**DESIGN COMMISSION  
MEETING**

# Administrative Staff Report

**Project:** Hillside Apartments

**File Number:** PLN-2022-02742

Figure 2 Ten-foot-wide landscaping strip along the Veteran's Memorial Dr. E. frontage.

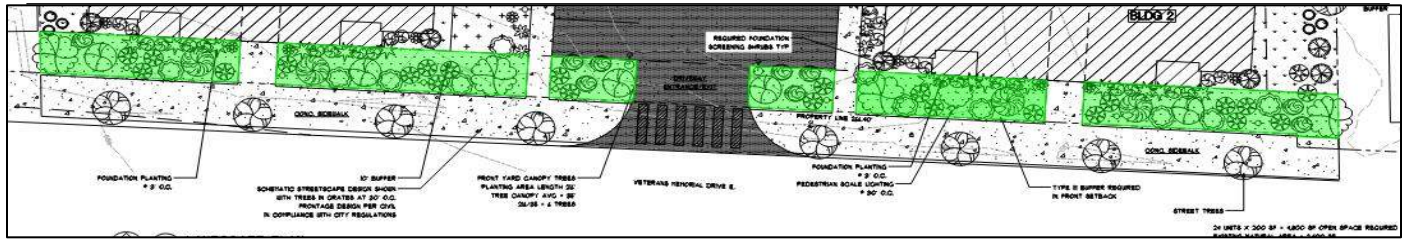
- b) Developments are required to provide a minimum 10-foot landscape strip or pedestrian-oriented space between the back of the sidewalk and the building, parking area, storage, or service area. The landscaping must include one (1) tree per 300 square feet of landscaped area, one (1) shrub per 20 square feet of landscaped area and enough ground cover to provide 100% coverage of the landscaped area after three (3) years. The project provides a 10-foot landscaping strip between the sidewalk and the building frontage. In addition, the landscape plan identifies 2,250 sq. ft. of landscaping between the building frontage and the sidewalk. The landscape plan does not provide information of the types of plantings. As a condition of approval, a more accurate planting plan identifying the types of plants will be required. Along the landscape frontage area, the eight (8) trees will be required and one-hundred and thirteen (113) shrubs.

Figure 3 Recommended trash enclosure location in yellow. Current location in blue.

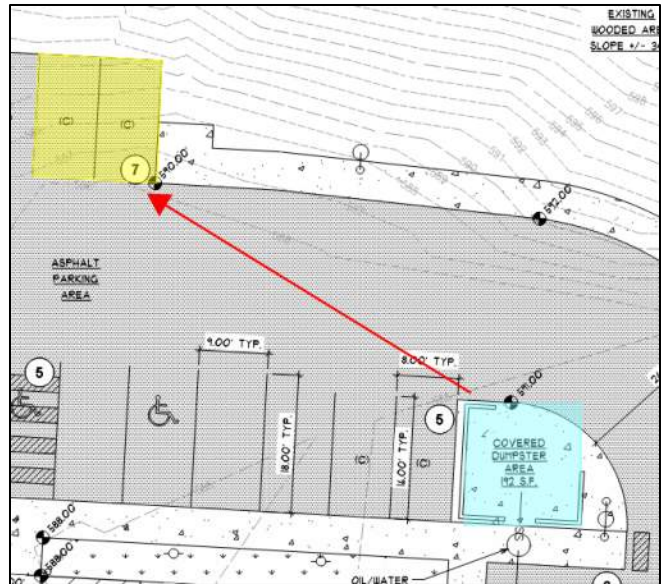
- a) Trash and recycling areas visible from the street, pathway, pedestrian-oriented space, or parking area shall be enclosed and screened by a wall or fence at least seven (7) feet tall, covered with a roof, and have self-closing doors. The project provides a covered trash enclosure. However, no elevations of the trash enclosure have been provided to verify the height and the type of doors. As a condition of approval, elevations of the trash enclosure shall be provided for review for the required building permit.

- b) Trash and recycling areas should be designed to match the architecture of the primary structures, including similar materials and/or detailing. The project provides a covered trash enclosure. However, no elevations of the trash enclosure have been provided to verify the architectural design. As a condition of approval, elevations of the trash enclosure shall be provided for review for the required building permit.

- c) If the trash enclosure is adjacent to a public or private street, sidewalk, or internal pathway, a landscaped planting strip a minimum of three (3) feet wide shall be required on three (3) sides of the facility. The project does not propose any landscaping around the trash enclosure, which is adjacent to the internal walkways of the site. As a condition of approval, the project will be required to add landscaping to three (3) sides of the trash enclosure to meet this standard.

Figure 4 Open space exhibit showing common open space (green), balconies (pink), natural areas (blue), and recommended open space areas (purple).

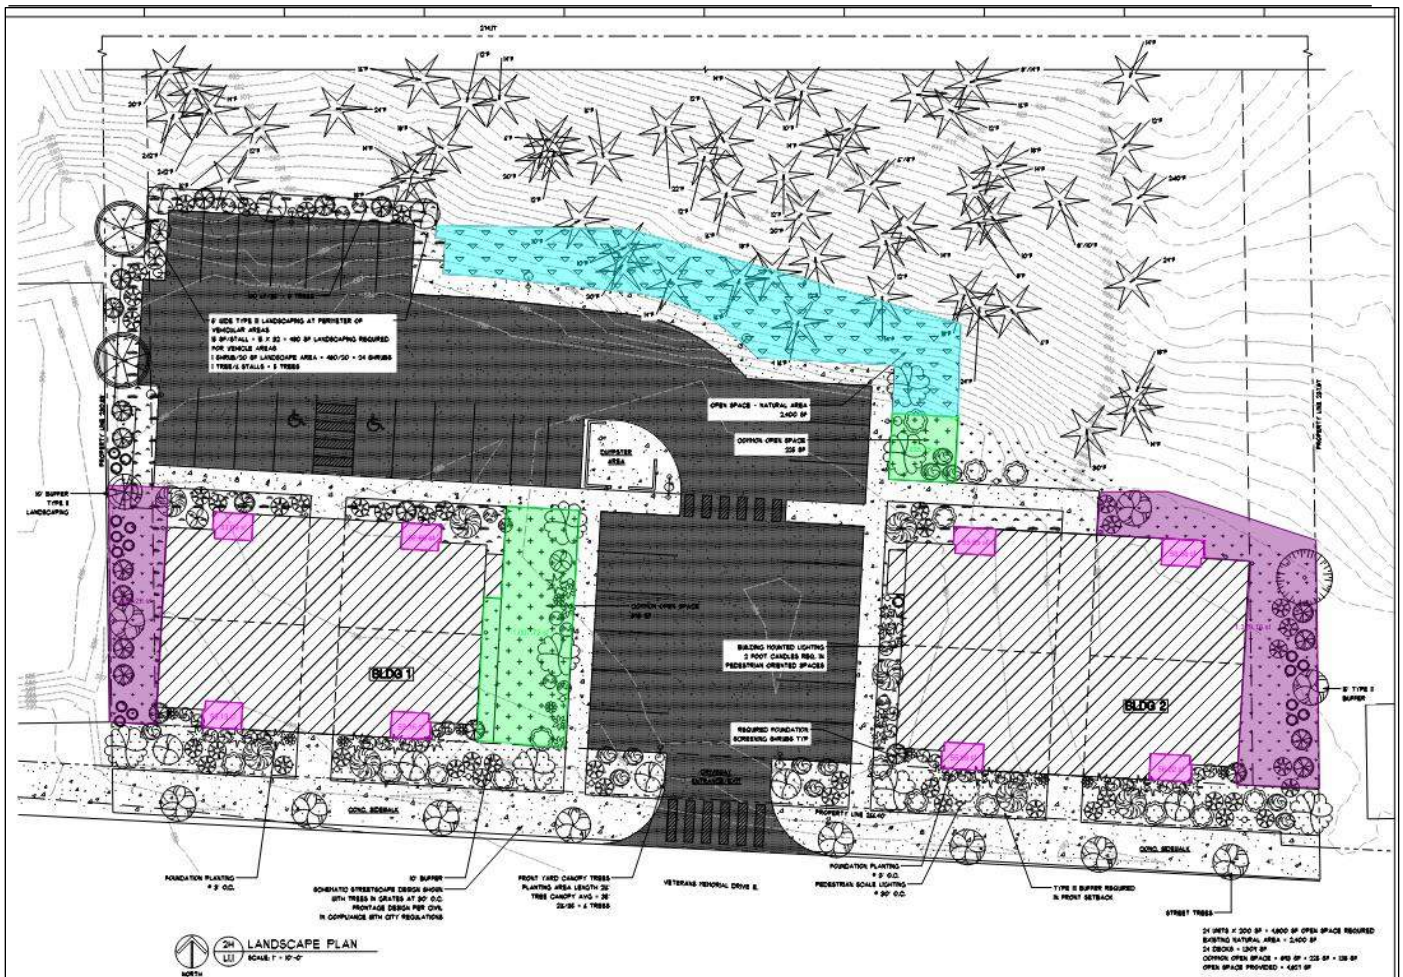
Multi-family uses must provide at least 200 square feet of open space per unit. Based on the proposed twenty-four (24) units, the project will be required to provide 4,800 square feet of open space<sup>8</sup>. Per the special requirements outlined in the DBLDS Section 2.3.1 (a)<sup>9</sup>, (b)<sup>10</sup>, (c)<sup>11</sup>, (d)<sup>12</sup>, and (e)<sup>13</sup>, the project’s open space is calculated in the table below.

The project is only showing 2,828 square feet of provided open space and will be required to provide additional open space. In addition, the proposed common open space will require amenities, such as playsets, meandering paths, benches, pedestrian scale lighting, and trash receptacles. As a recommendation and shown in Figure 4, the areas in purple can be considered open space, if the project provides some of the amenities described above, specifically a garden path and benches. If these areas are incorporated into the open space requirement, the project would provide 4,811 square feet of open space, which would satisfy the open space requirement. As a condition of approval, the project is to provide additional open space to meet the square footage allocation and provide amenities within the already proposed common open space areas.

BONNEY LAKE HILLSIDE APARTMENTS	
BUILDING 1 - EXTERIOR ELEVATIONS	
JULY 15, 2022	Page 2 of 9

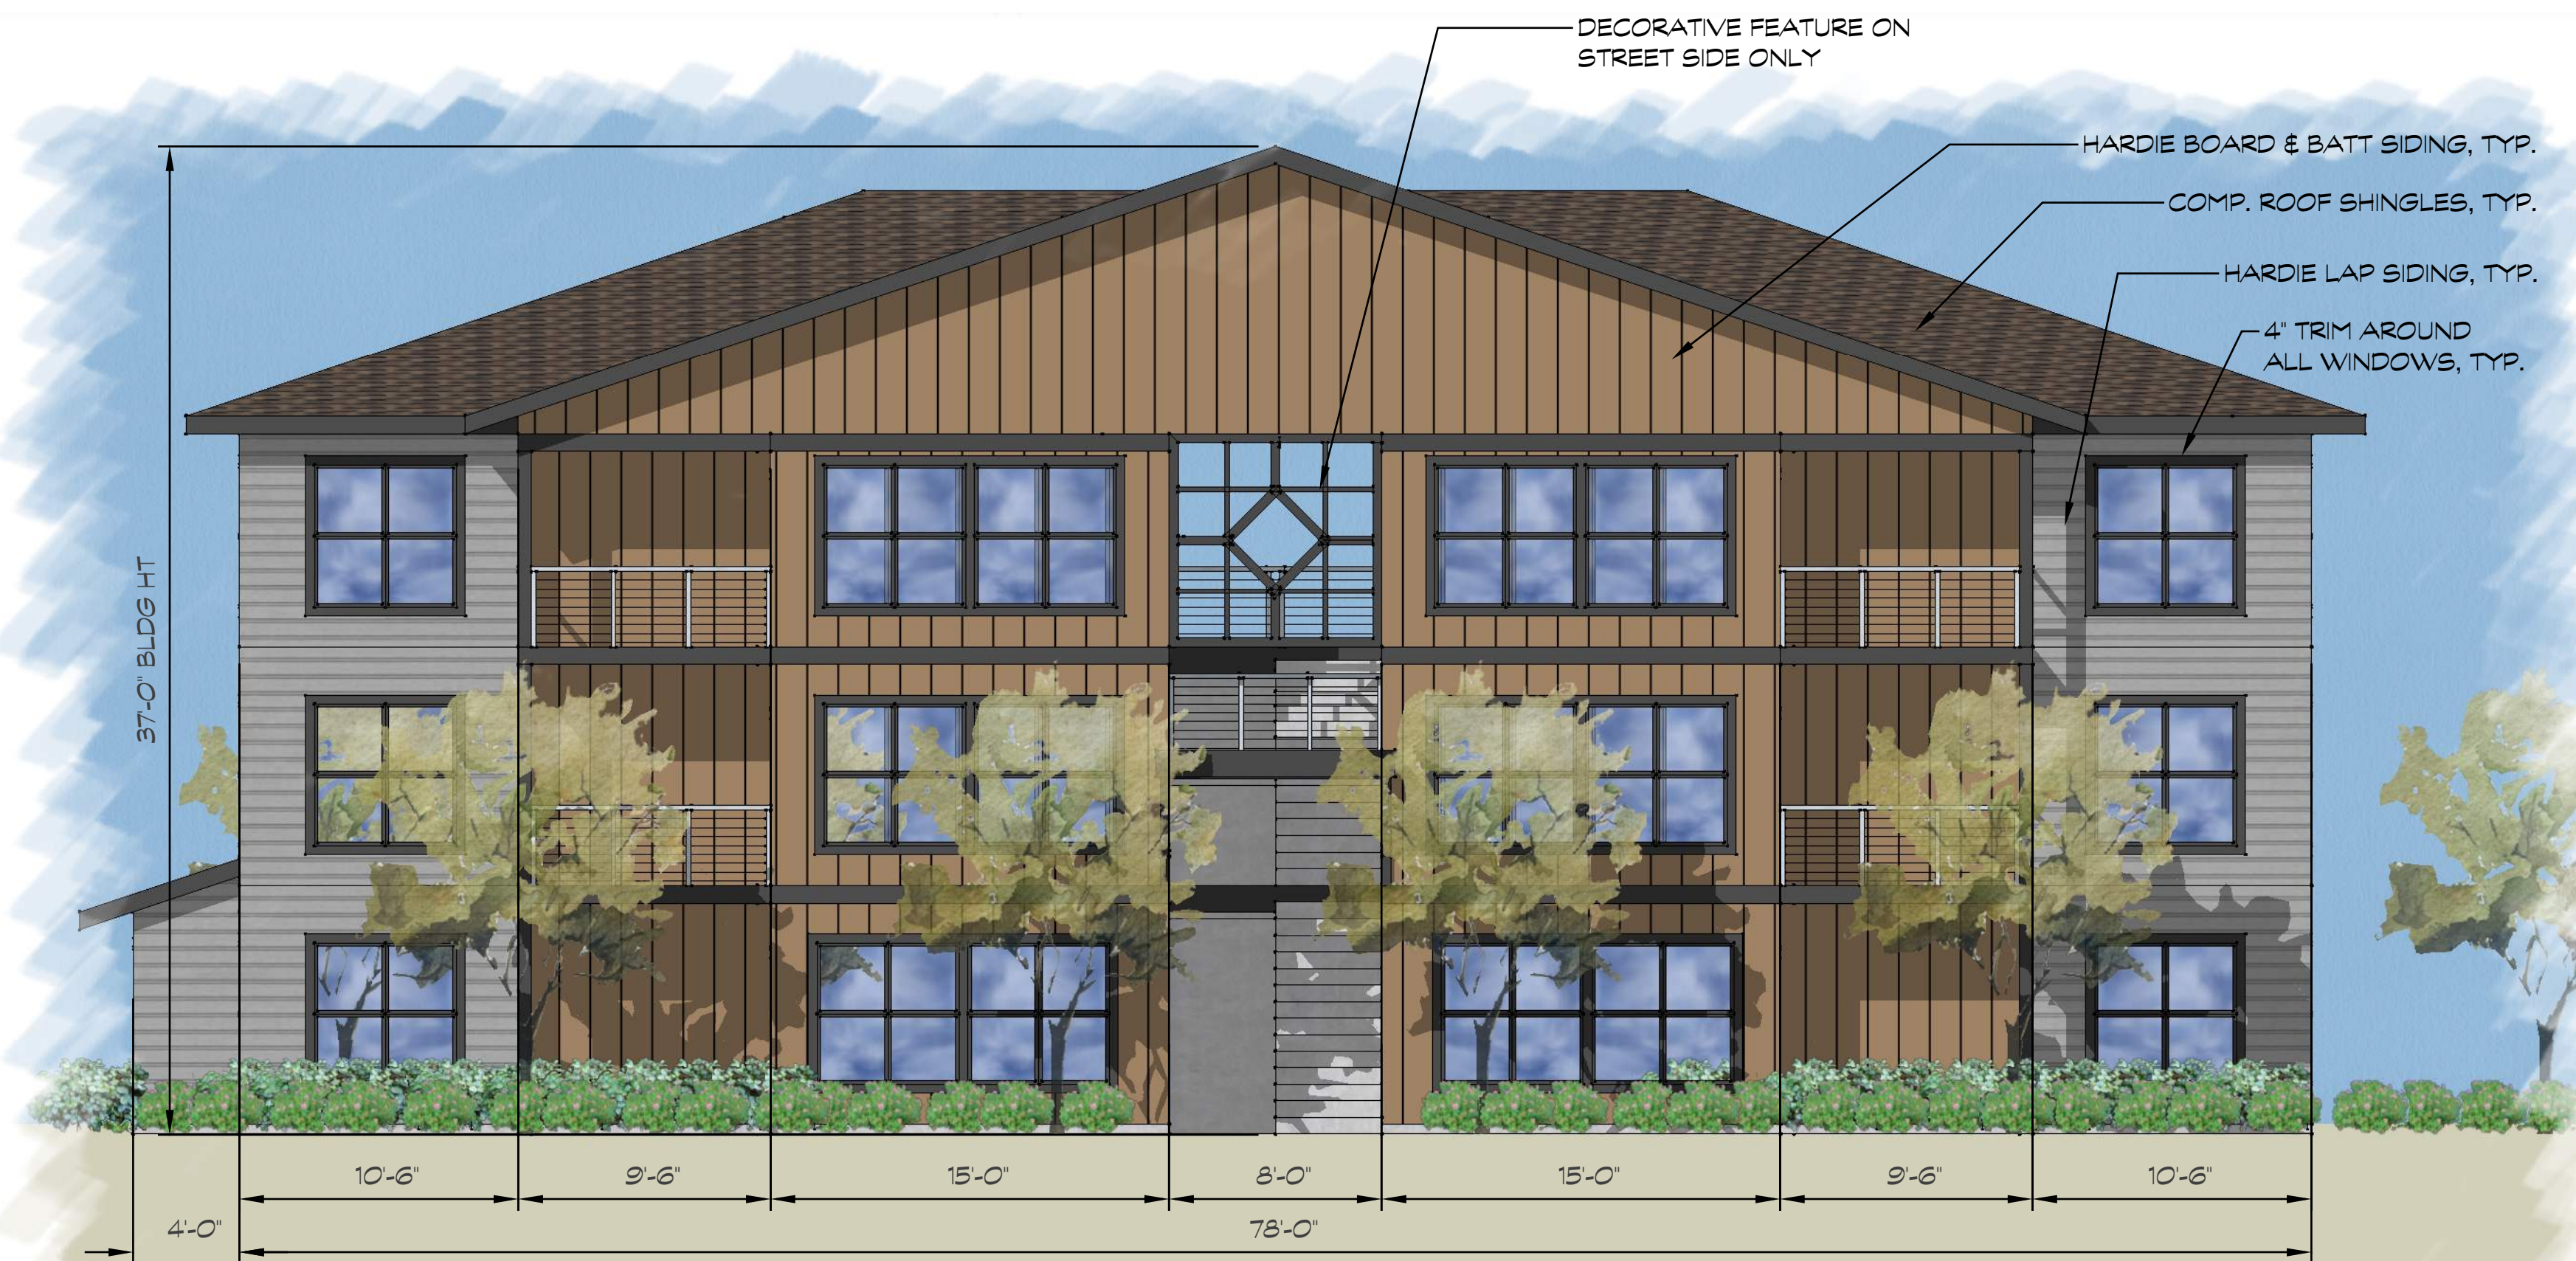
All residential buildings and residential portions of mixed-use buildings shall include at least three (3) modulation and/or articulation features<sup>14</sup> at intervals no more than thirty (30) feet along all façades facing a street, common open space, and common parking area. Along the north and south façades of building 1 and building 2, the project design shows repeating window features at maximum intervals of fifteen (15) feet, provides a distinct top, middle, and bottom floor, and vertical modulation, which shows separated vertical planes that setback four (4) feet. However, utilizing the minimum four (4) foot standard must include a change in material, color, or roofline. The portion of the building that is setback to include the balcony will require a change in material, color, or roofline to

Figure 6 shows the area along the south facade that will need to utilize a different material/color to meet the articulation standard.

Along the east and west façades of building 1 and building 2, the project design shows repeating window features at maximum intervals of fifteen (15) feet and vertical modulation. However, it is lacking in a third feature. It is recommended that the applicant update the east and west façades to include a distinctive top, middle, and bottom, which could be accomplished similarly to the north and south façades. As a condition of approval, the west and east façades of buildings 1 and 2 will need to provide another architectural feature that is outlined in DBLDS

8. The west and east façades of buildings 1 and 2 will need to provide another architectural feature as outlined in DBLDS 4.2.3
9. The project will be required to place a “year of construction” plaque that follows the requirements outlined in the DBLDS 4.3.2.
